<b>marantz®</b> <b>SERVICE BULLETIN</b>		Date: 15-May-2003	Model: SR5200/SR6200/SR7200
		Page: 1/2	REF.NBR: MZ02-033
Circulation:		Subject:	
Application:		Hum noise can be heard from Headphone out.	
x for information customer complaint in case of service mandatory			
		See below

<b>marantz®</b> <b>SERVICE BULLETIN</b>		Date: 15-May-2003	Model: SR5200/SR6200/SR7200
		Page: 1/6	REF.NBR: MZ02-032
Circulation:		Application:	
x for information customer complaint in case of service mandatory		See below	
		Subject:  Pop noise	
		Int.ref:

<b>marantz®</b> <b>SERVICE BULLETIN</b>		Date: 27-Sep-01	Model: SR5200/6200/7200
		Page: 1/2	REF.NB MZ01-016
Circulation:		Application:	
x for information customer complaint in case of service mandatory .....		<b>Refer to following.</b>	
		Subject:  The noise (stripes) occur on the picture.	
		Int.ref

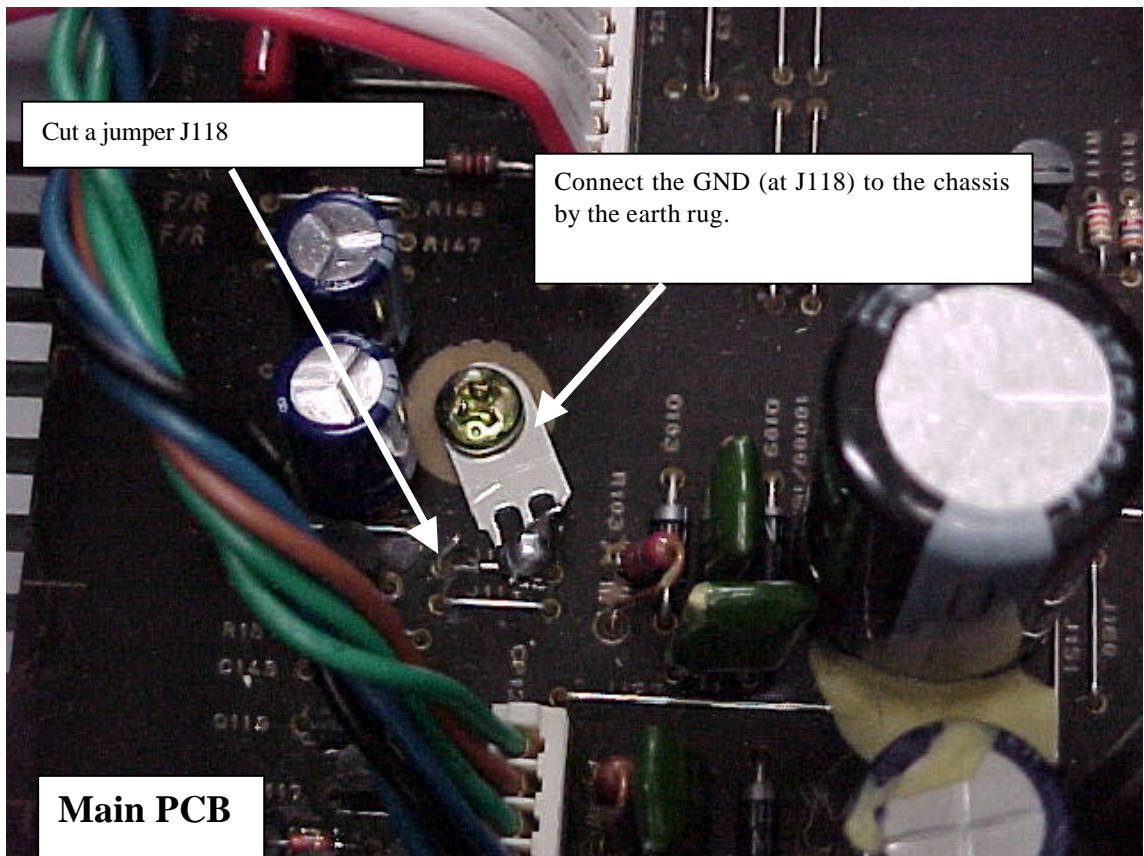
Hum noise can be heard from Headphone out

Caused by ground loop of the headphone out.

Please apply the following solution.

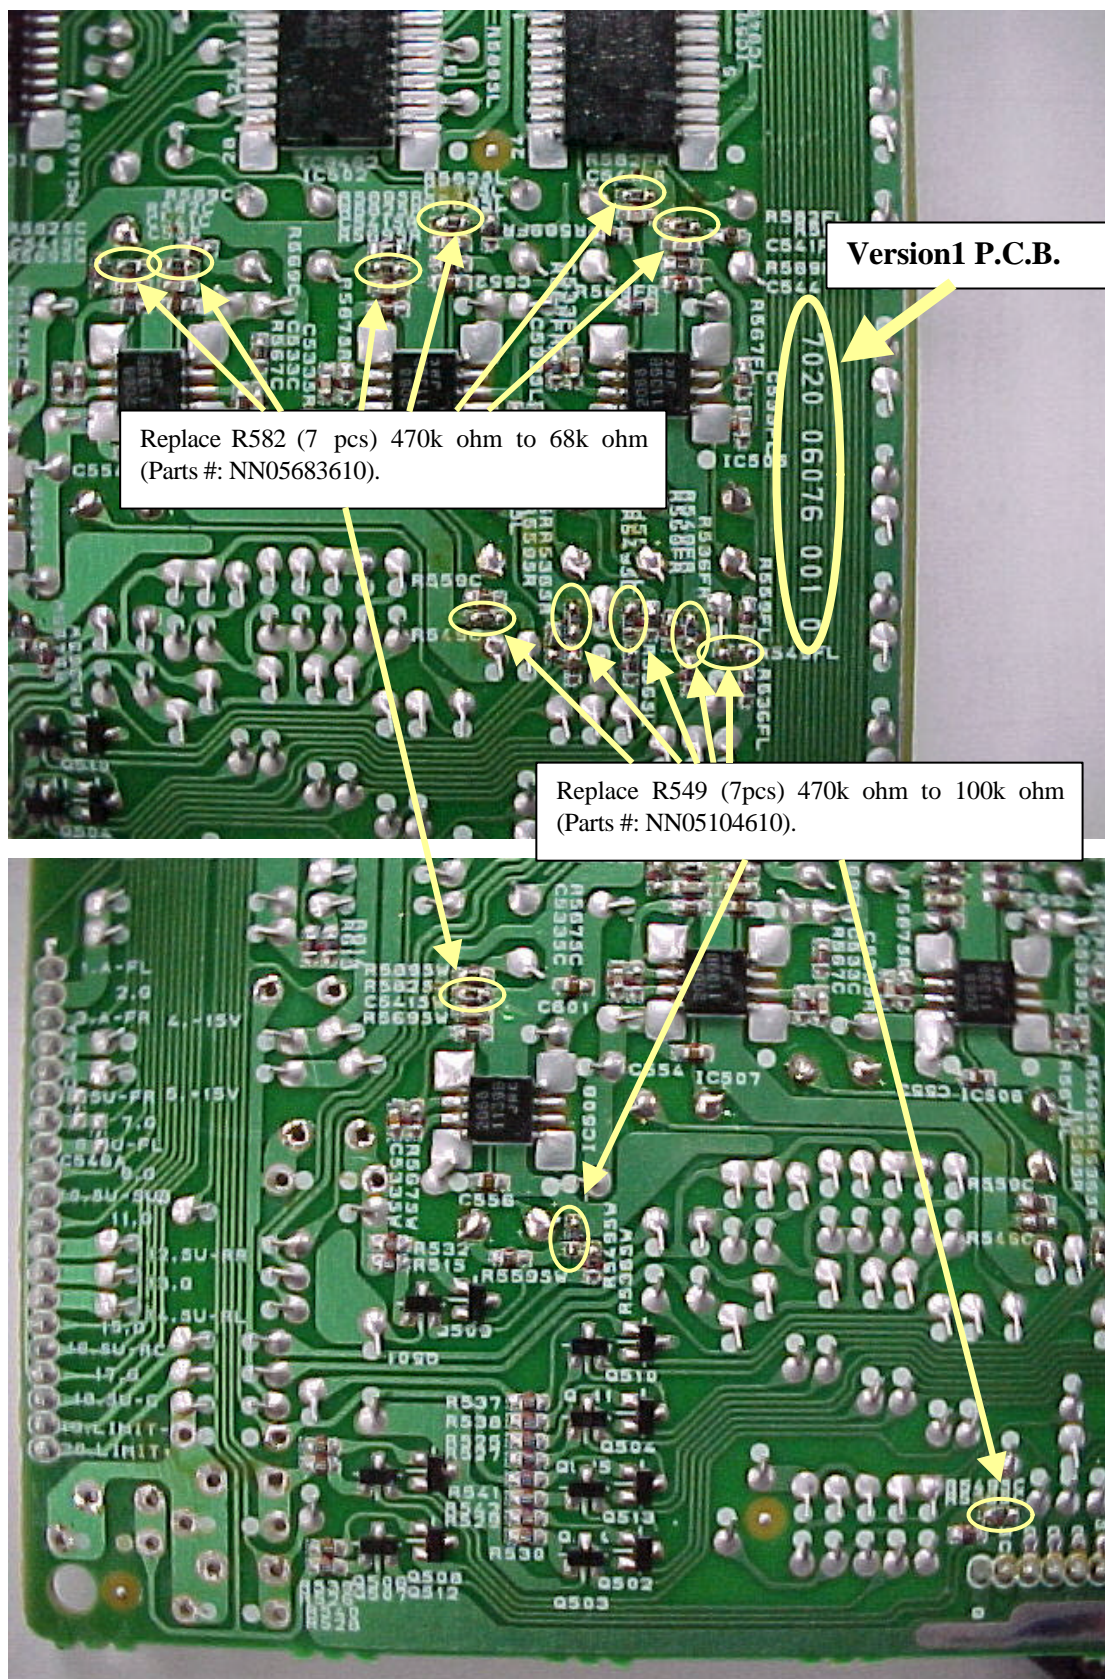
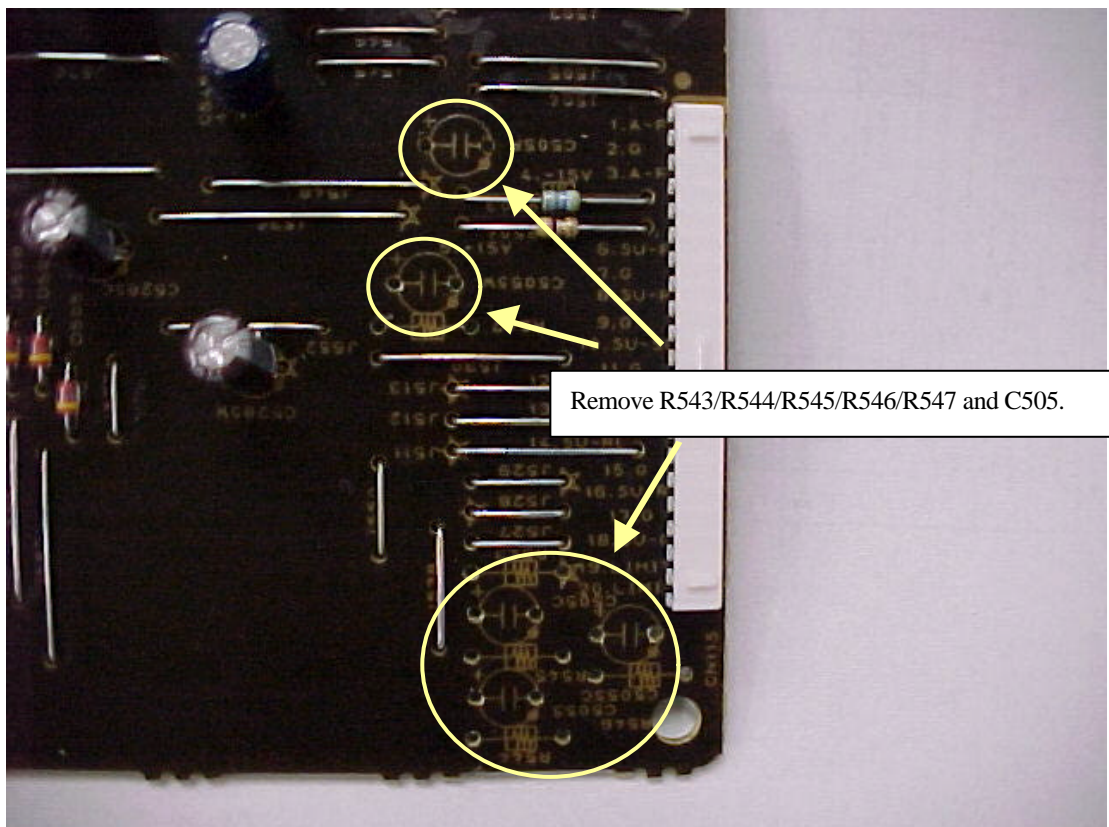
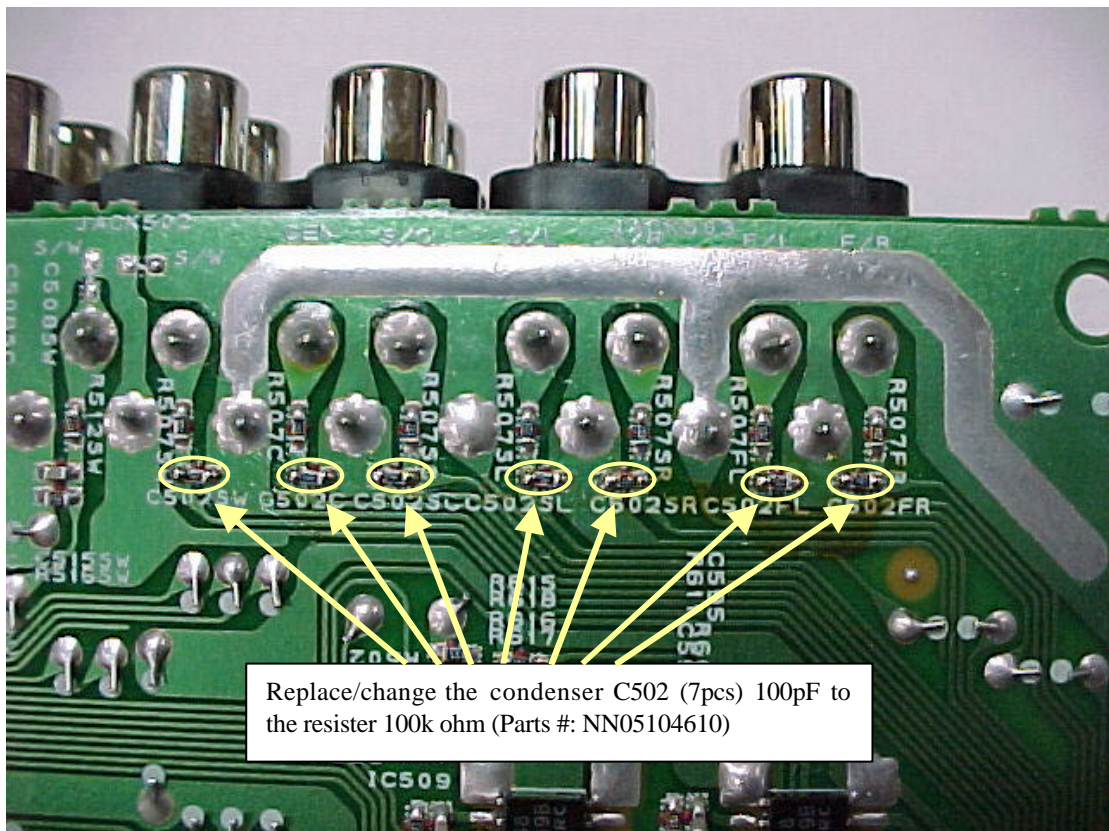
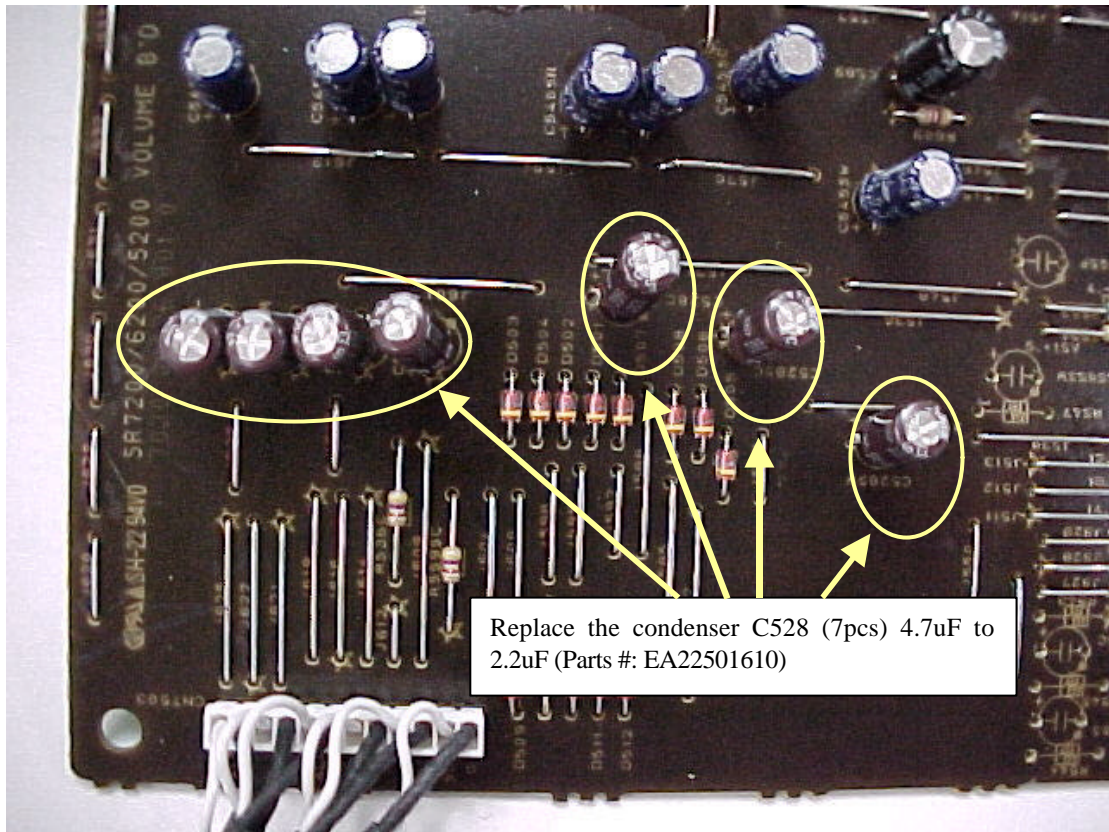
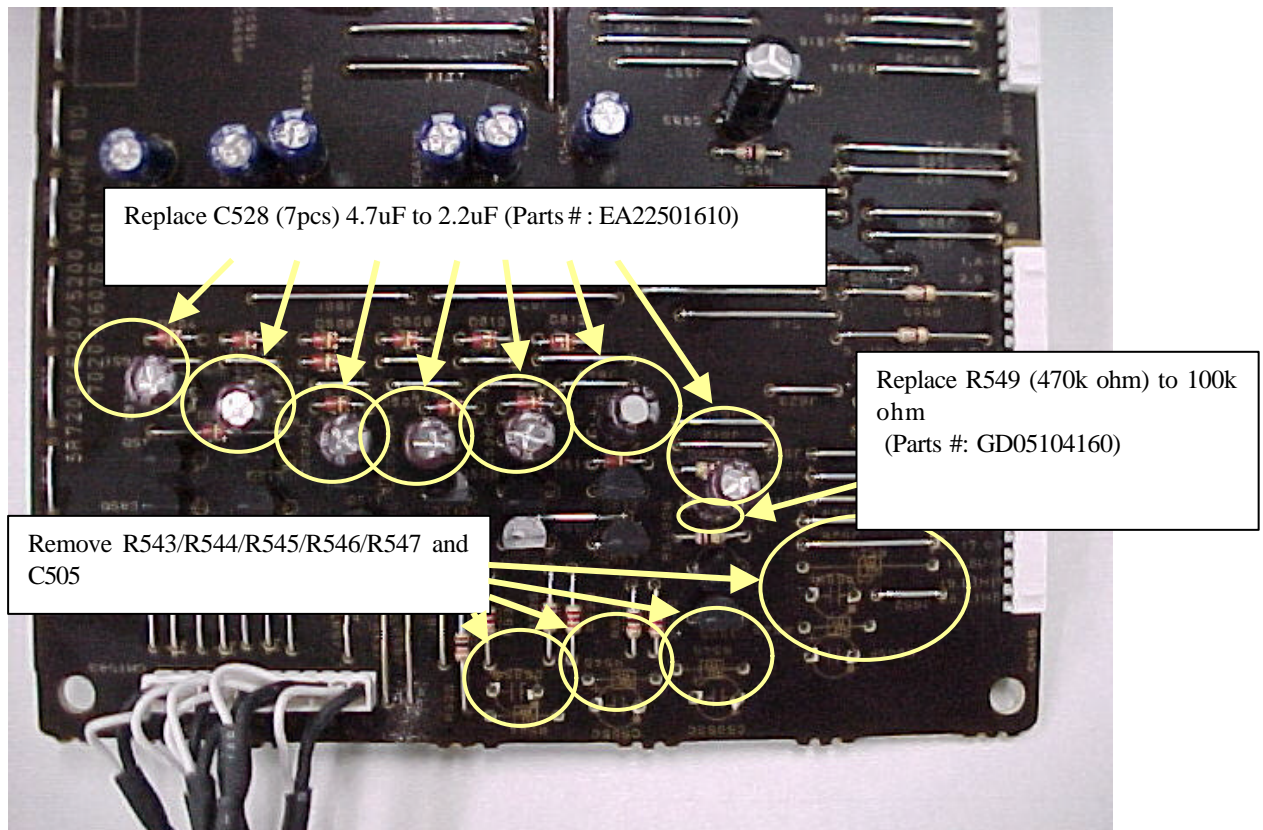
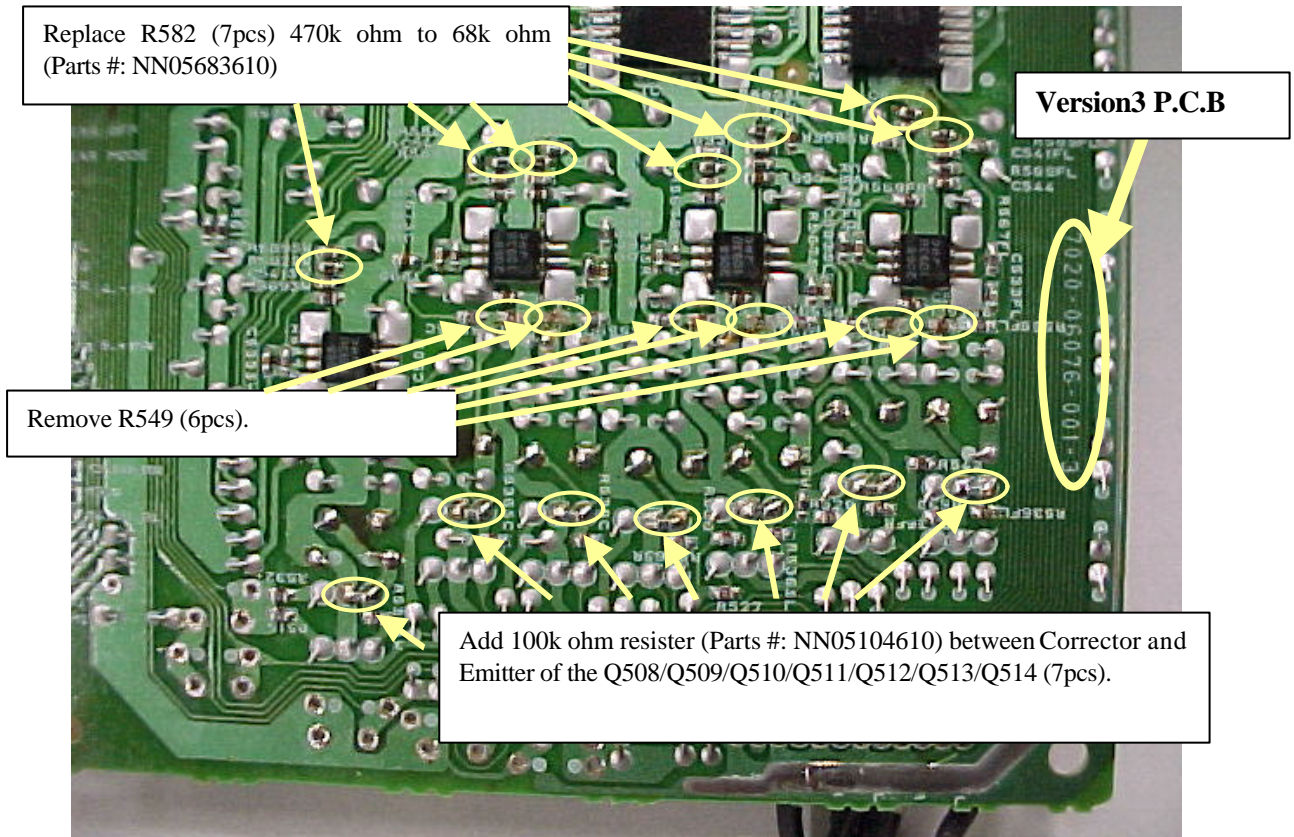
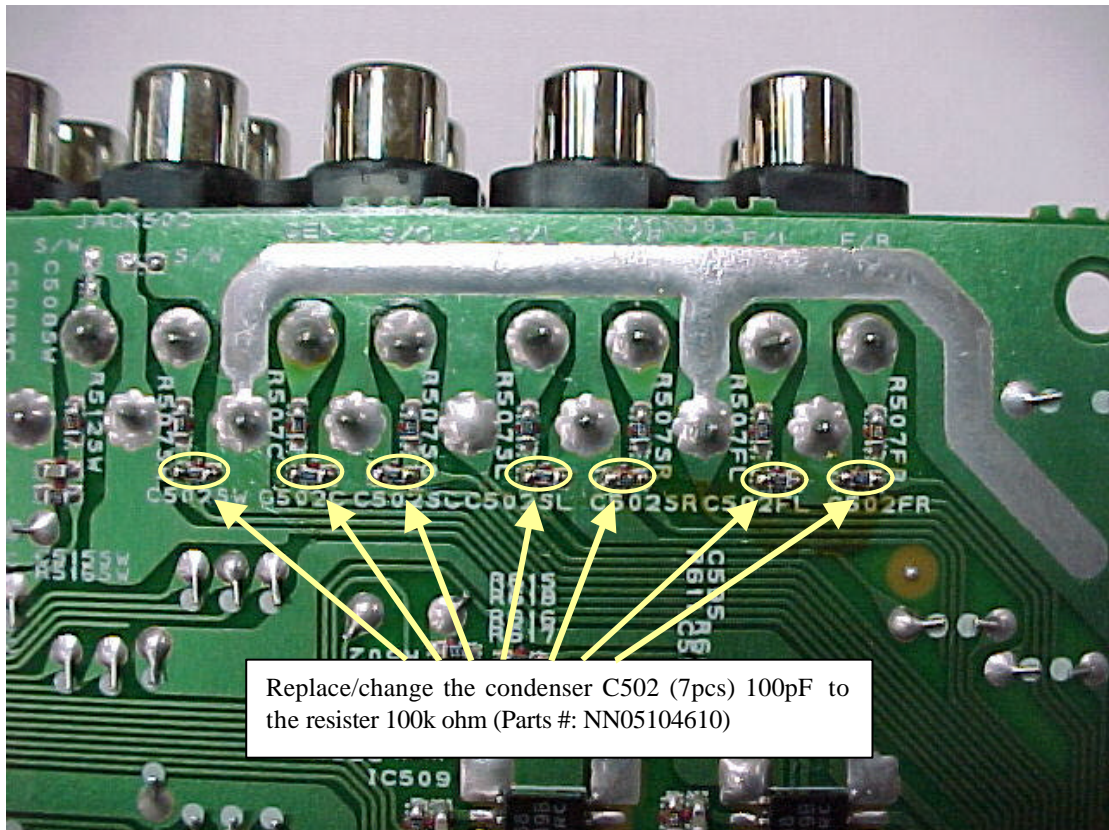
Pop noise appears when stop playing or track skip on CD playback with Digital connection.  
Pop noise appears in the condition of the Main volume is changed 74dB to 75dB(Mute) .

Please apply the modifications as mentioned in page 2 to page 6.

\* Version 1 P.C.Board (7020 06076 001-0) : Please apply the modification mentioned on Page2 to 4.

\* Version 2 P.C.Board (7020 06076 001-3) : Please apply the modification mentioned on Page5 to 6.

\* Version 1 P.C.Board (7020 06076 001-0) : Please apply the modification mentioned below (Page2 to 4).

\* **Version 3 P.C.Board (7020 06076 001-3)** : Please apply the modification mentioned below (Page 5 to 6).

PIC.01

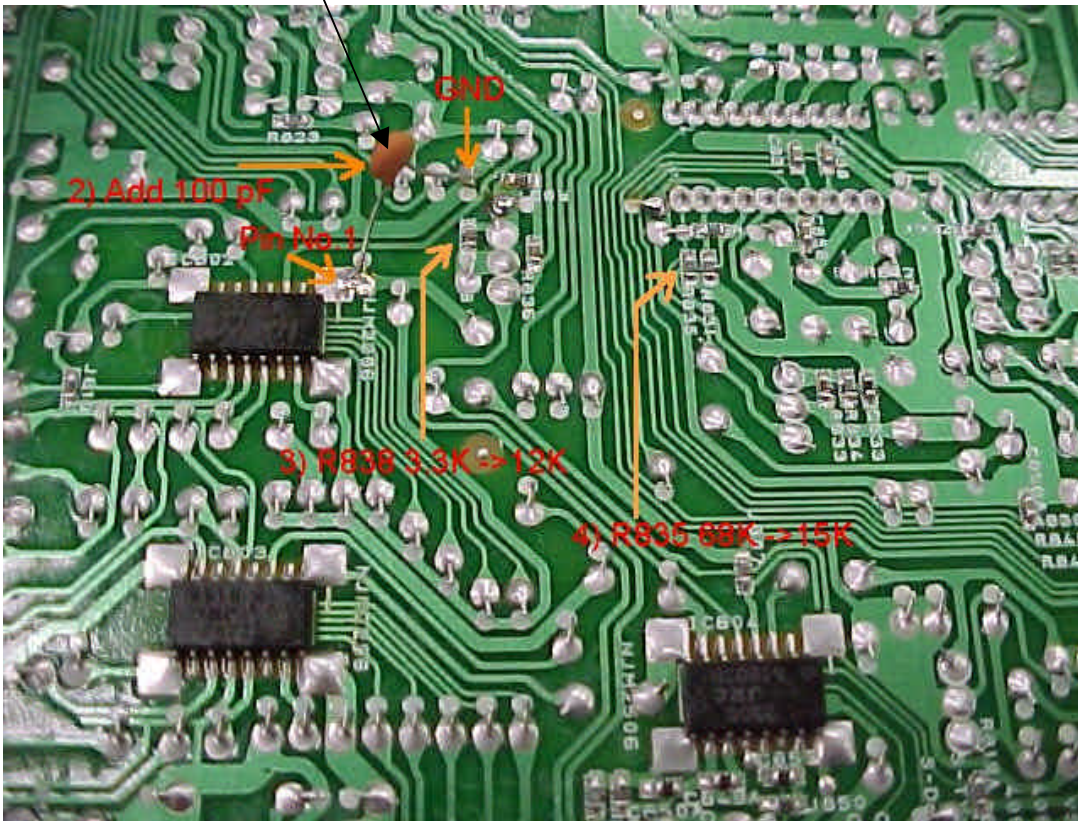
- 1) The capacitor(C810A 100pF: DK16101300 4822 122 33195) is added between 1P of IC802 and GND(refer to PIC.01).
- 2) The jumper wire(J841) is deleted and a capacitor(C840A 47uF/16V: EA47601620 9965 000 06289) is added to same position (refer to PIC.02).
- 3) The chip resistor(R838) is changed into 12kohm one(NN05123610 4822 051 30123) from the present 3.3kohm one.
- 4) The chip resistor(R835) is changed into 15kohm one(NN05153610 4822 051 30153) from the present 68kohm one.

C810A (100pF: DK16101300

4822 122 33195)

**C146 on the MAIN CIRCUIT BOARD**

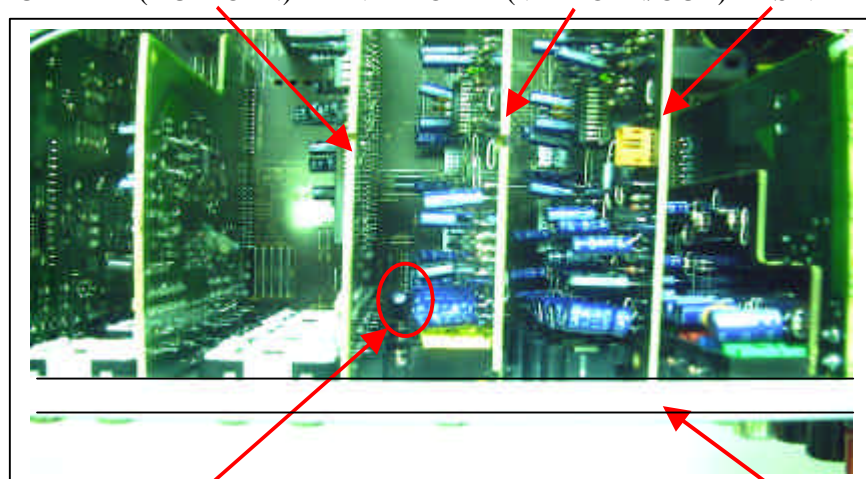
The POP noise occurs from Center speaker, Surround L/R and Surround Center speaker when POWER ON.

Because the IC of the speaker drive circuit has time lag , a transistor becomes on under the condition of un-stability to output when POWER ON, and POP noise is occurred.

Electrolytic capacitor **C146(10uF/50V)** is changed to **47uF/16V** on the **MAIN CIRCUIT BOARD**.
